May 21, 2018
IDEA PUBLIC SCHOOLS – IDEA Brownsville Robindale Phase I

ADDENDUM NO. 1

A. PURPOSE AND INTENT
This addendum is issued for the purpose of modifying the plans and specifications for the IDEA PUBLIC SCHOOLS – IDEA Brownsville Robindale Phase I

Date: May 10, 2018
Scale: As Noted
Project Architect: David Monreal, AIA
Drawn By: ETHOS
Job No.: IDEA Robindale Phase I
Sheet: E3.04

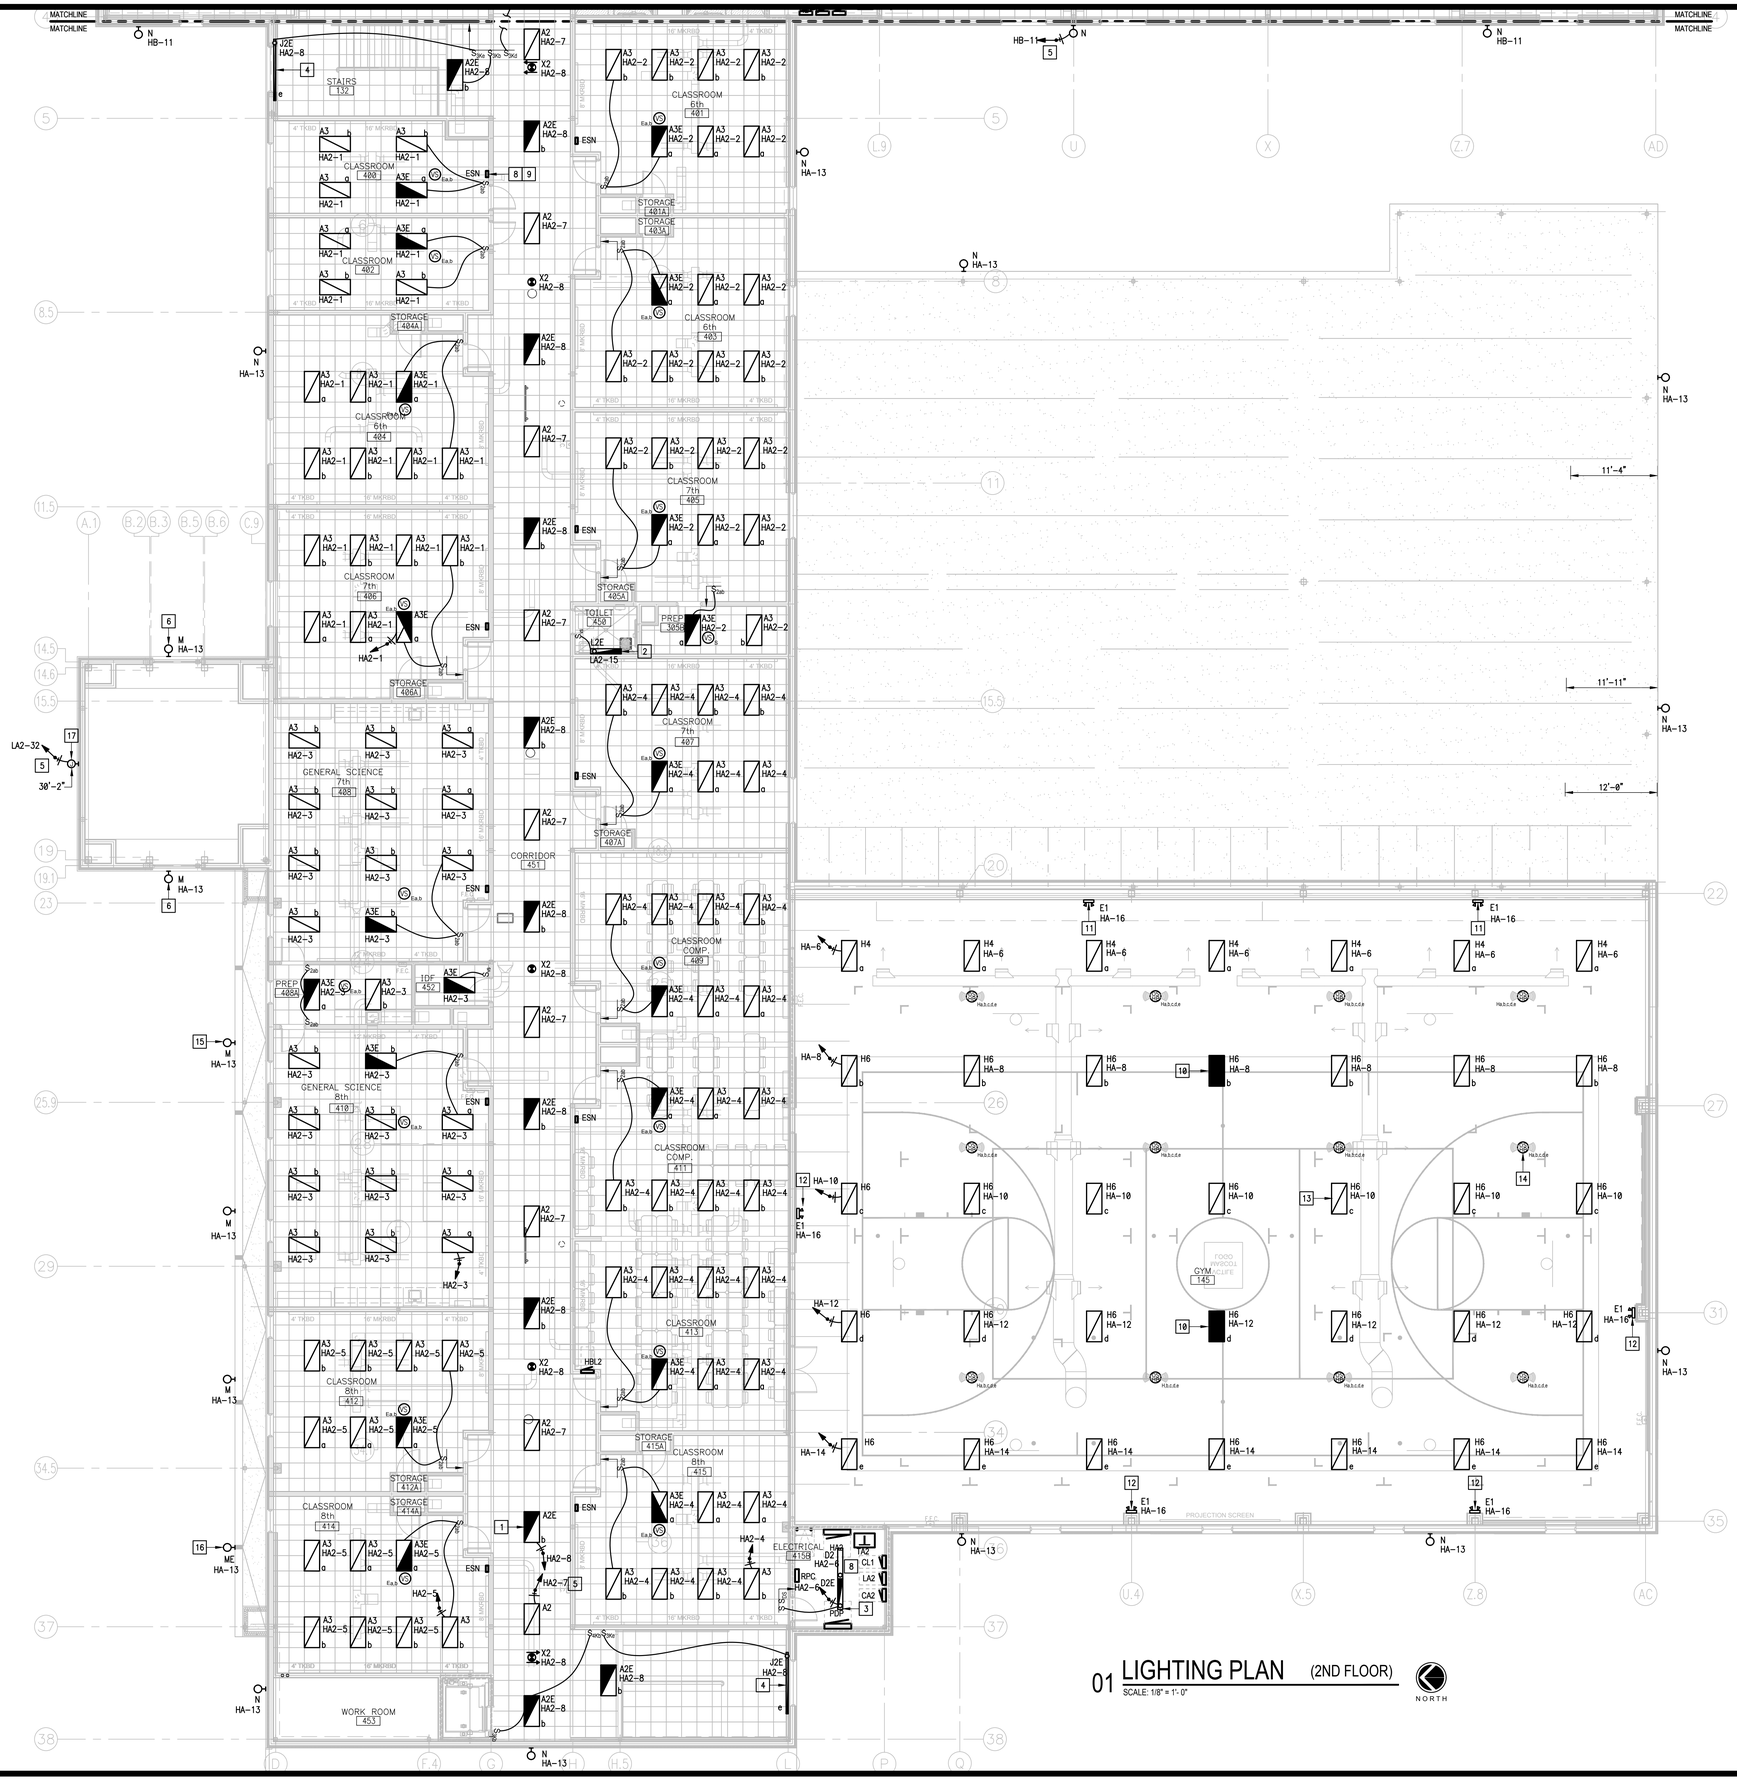
7) Sheet E3.04:
   a) Revised Second Floor Lighting Plan. See attached sheet.

Date:	May 10, 2018
Scale:	As Noted
Project Architect:	David Monreal, AIA
Drawn By:	ETHOS
Job No.	IDEA Robindale Phase I
Sheet:	E3.05

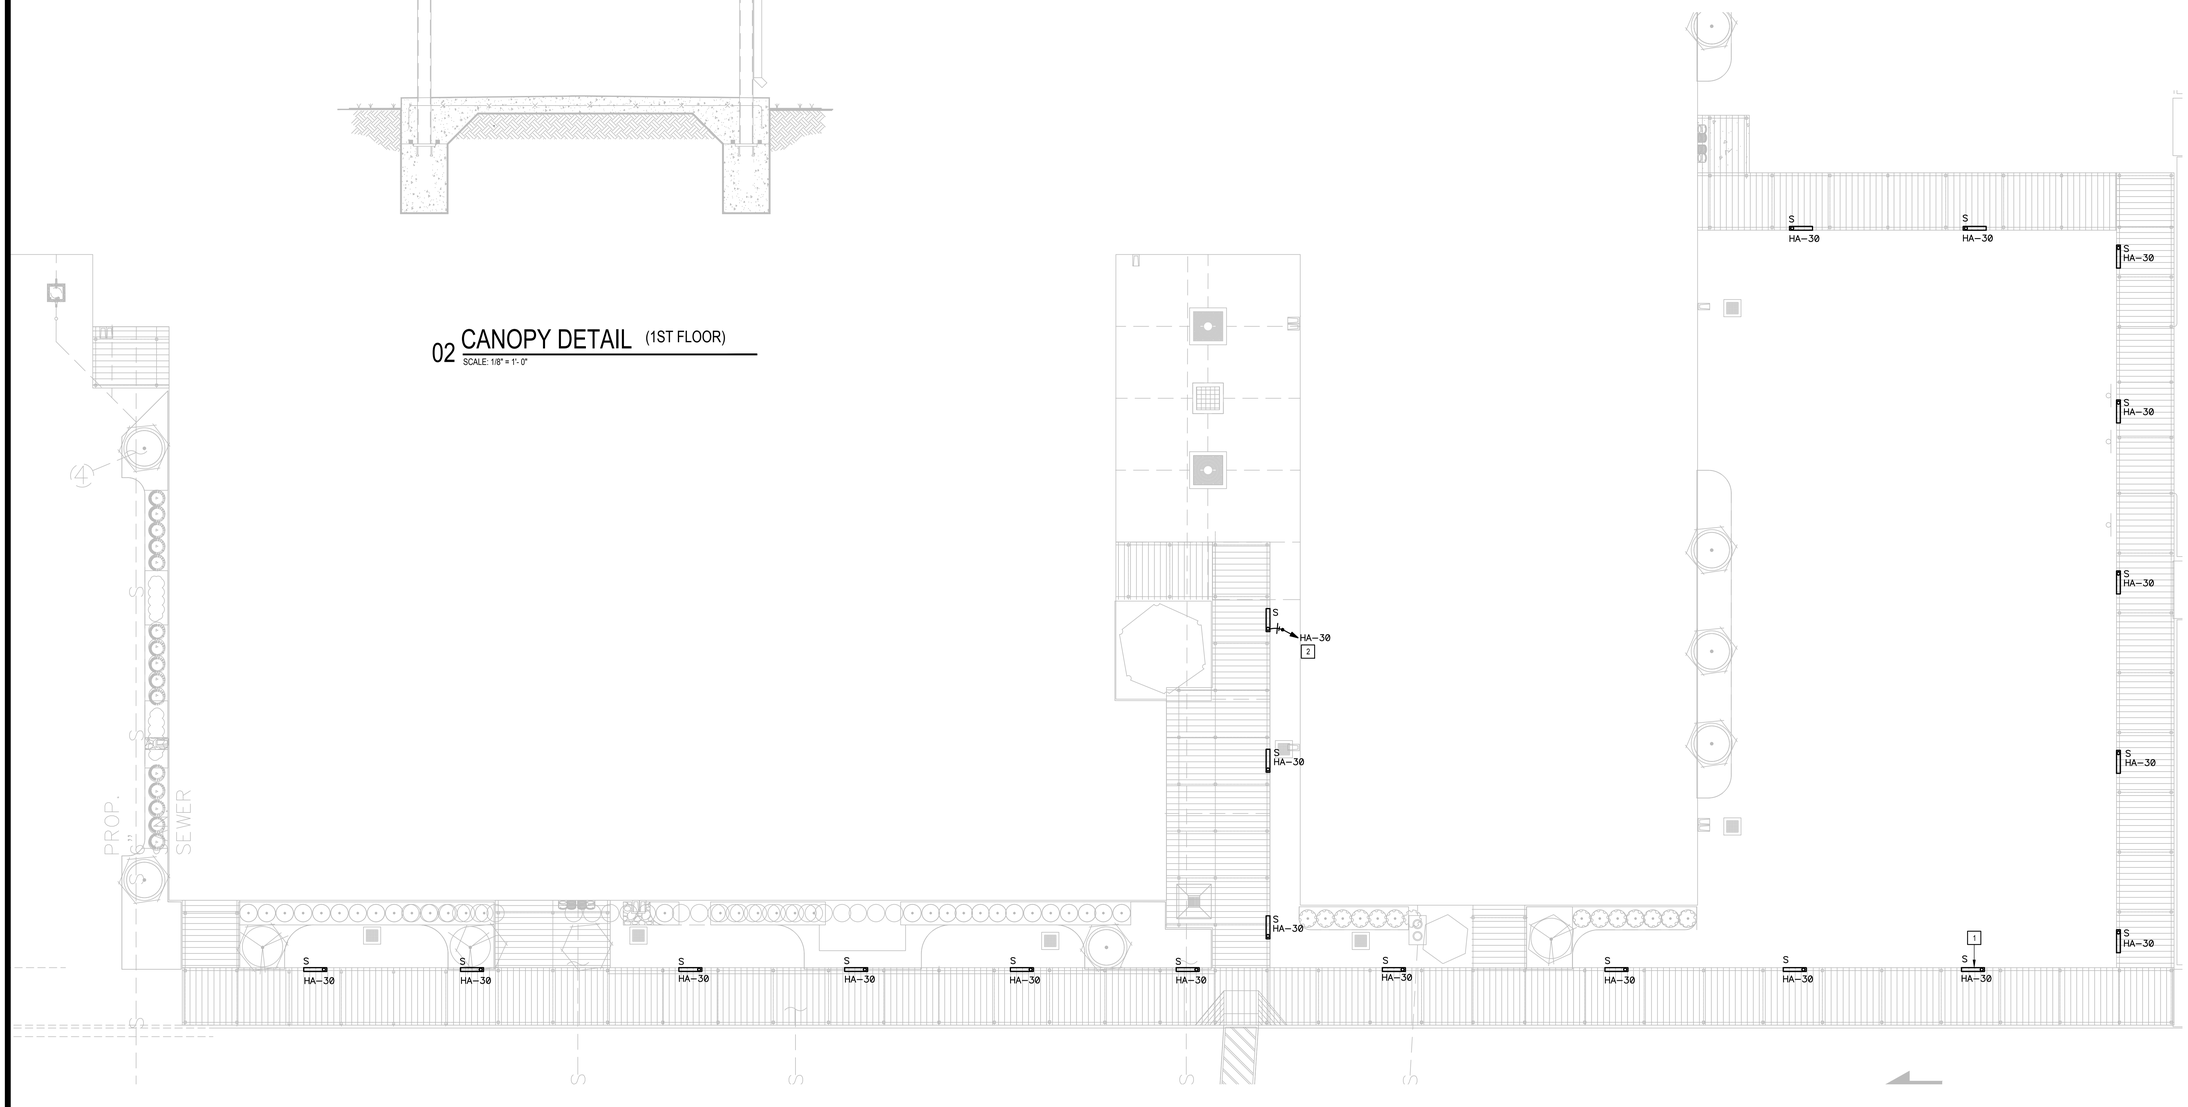
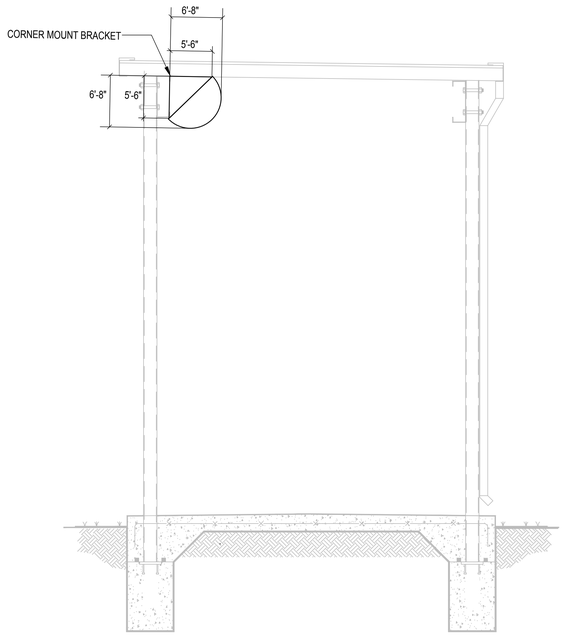
8) Sheet E3.05:
   a) Revised Canopy Lighting Plan. See attached sheet.

Date:	May 10, 2018
Scale:	As Noted
Project Architect:	David Monreal, AIA
Drawn By:	ETHOS
Job No.	IDEA Robindale Phase I
Sheet:	E4.01

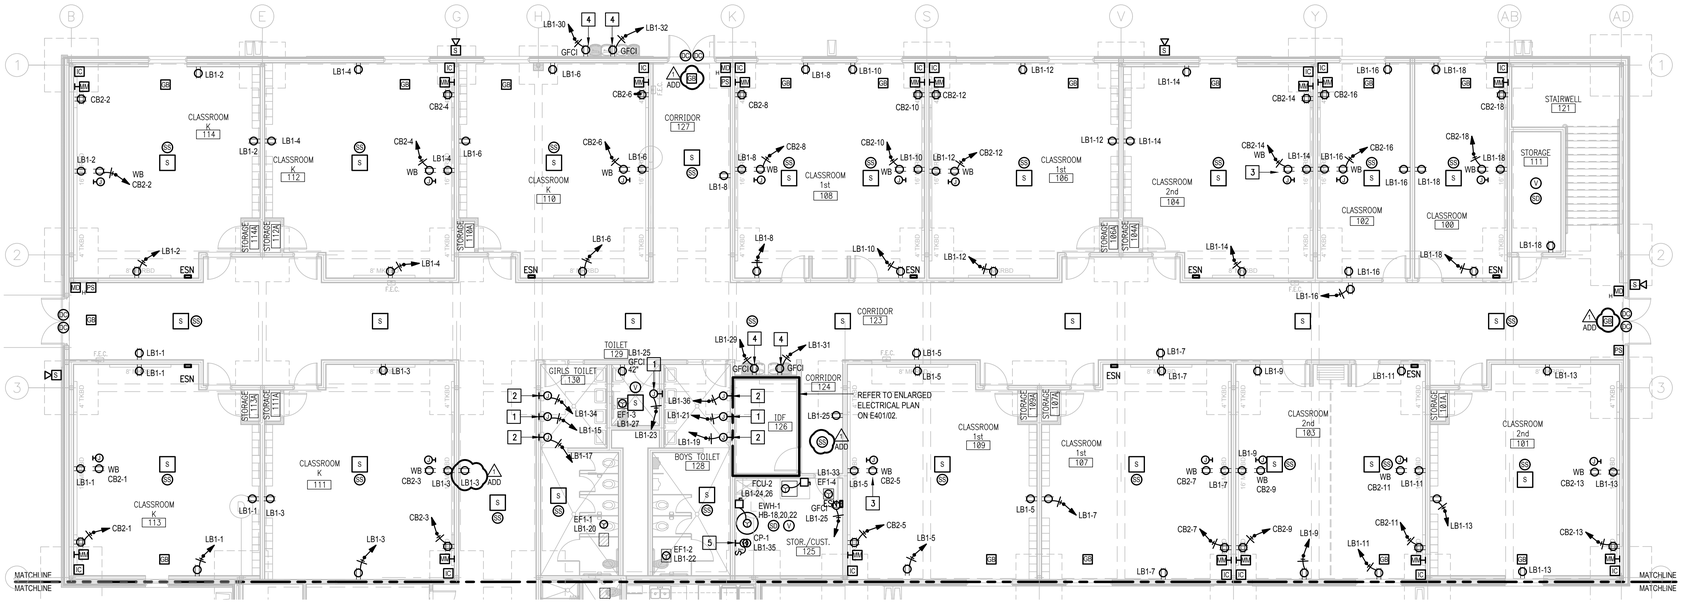
9) Sheet E4.01:
   a) Revised First Floor Electrical Plan. See attached sheet.

Date: May 10, 2018
Scale: As Noted
Project Architect: David Monreal, AIA
Drawn By: ETHOS
Job No. IDEA Robindale Phase I
Sheet: E4.02

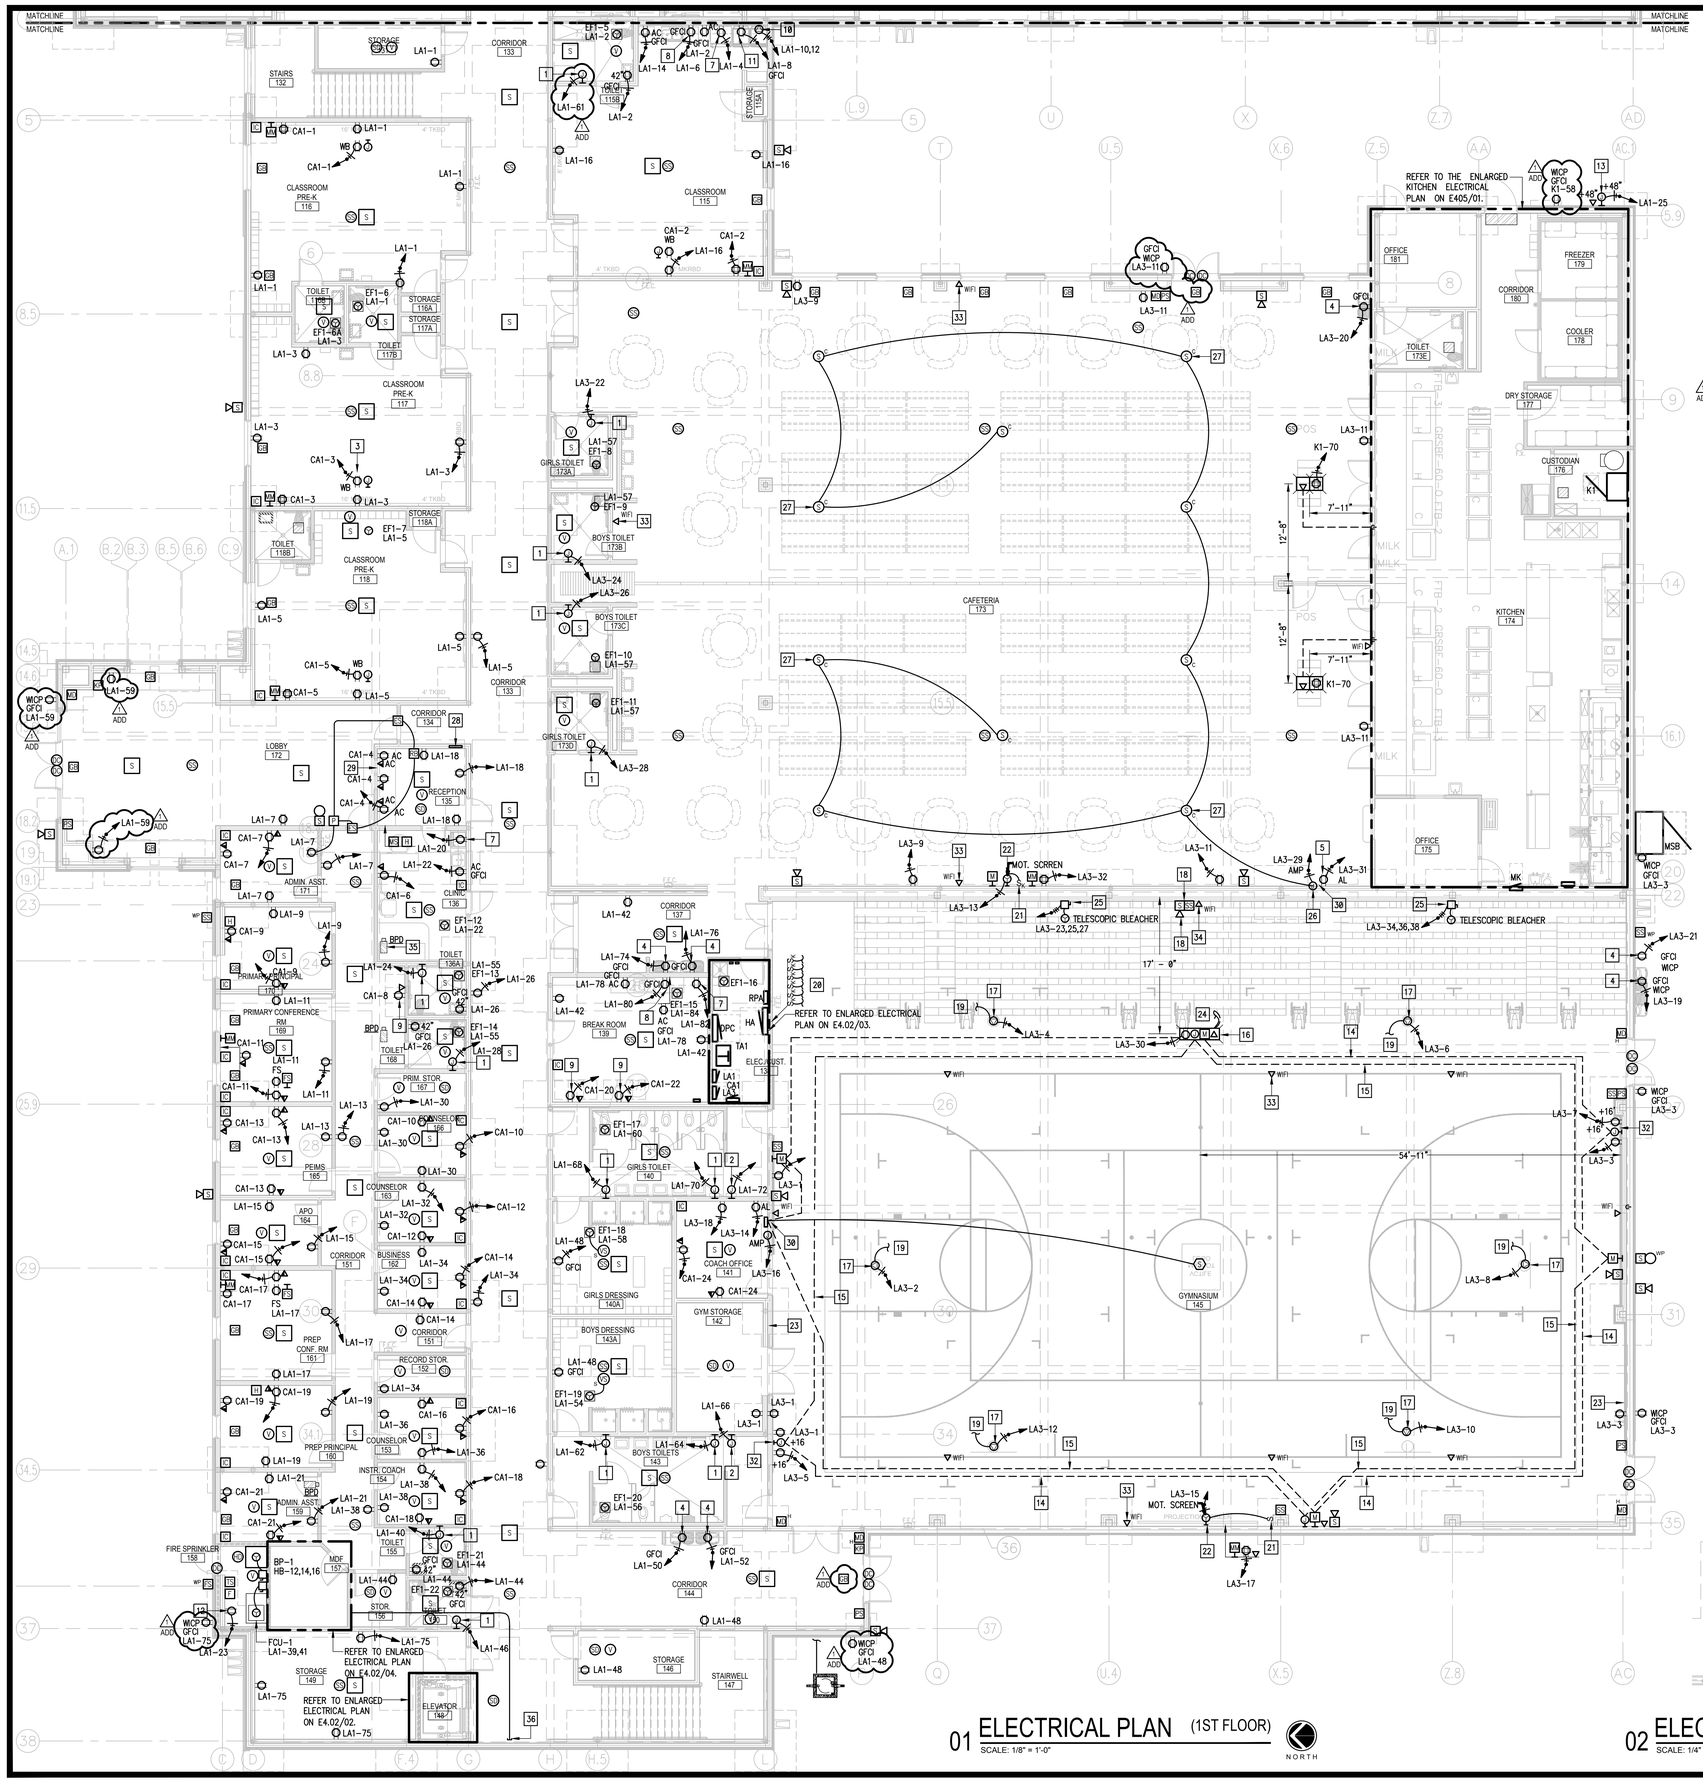
10) Sheet E4.02:
   b) Revised First Floor Electrical Plan. See attached sheet.

Date:	May 10, 2018
Scale:	As Noted
Project Architect:	David Monreal, AIA
Drawn By:	ETHOS
Job No.	IDEA Robindale Phase I
Sheet:	E4.03

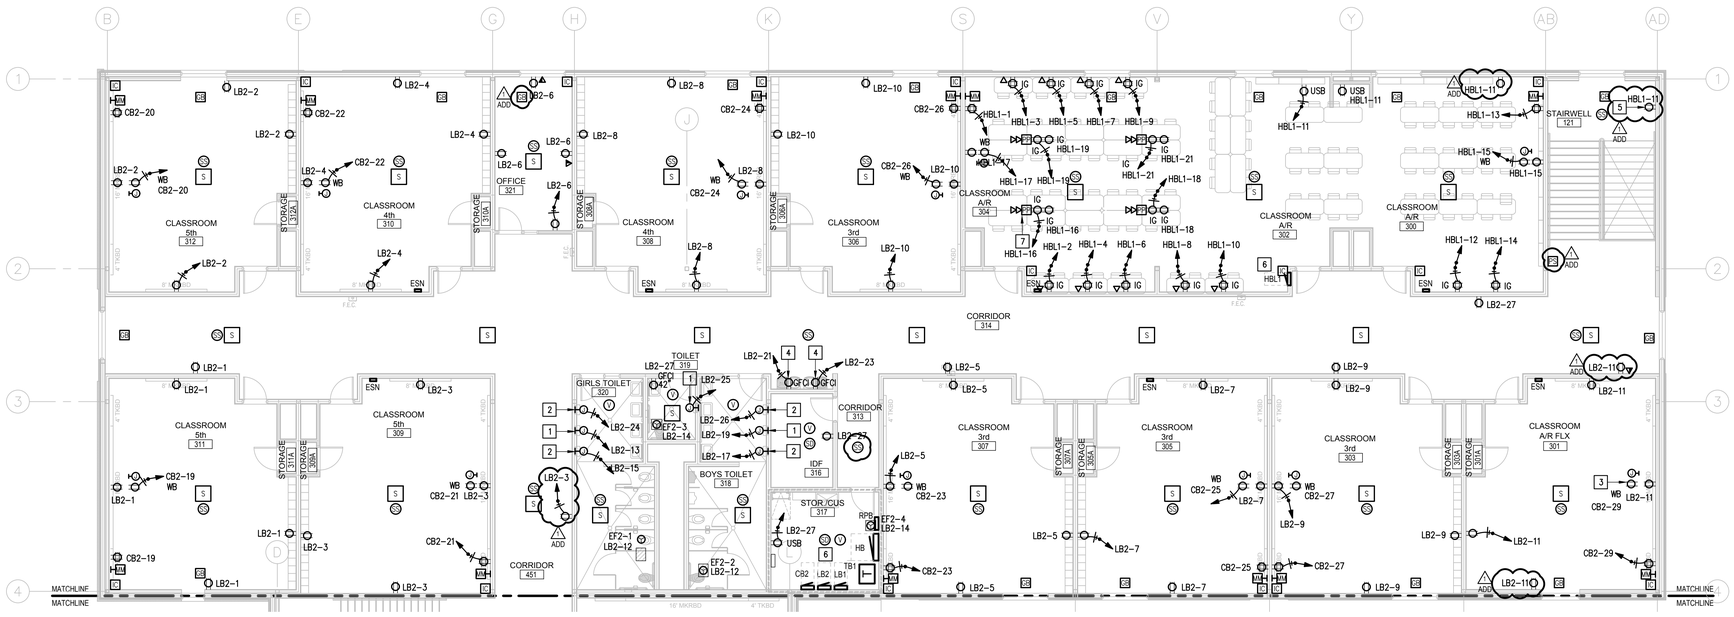
11) Sheet E4.03:
   c) Revised Second Floor Electrical Plan. See attached sheet.
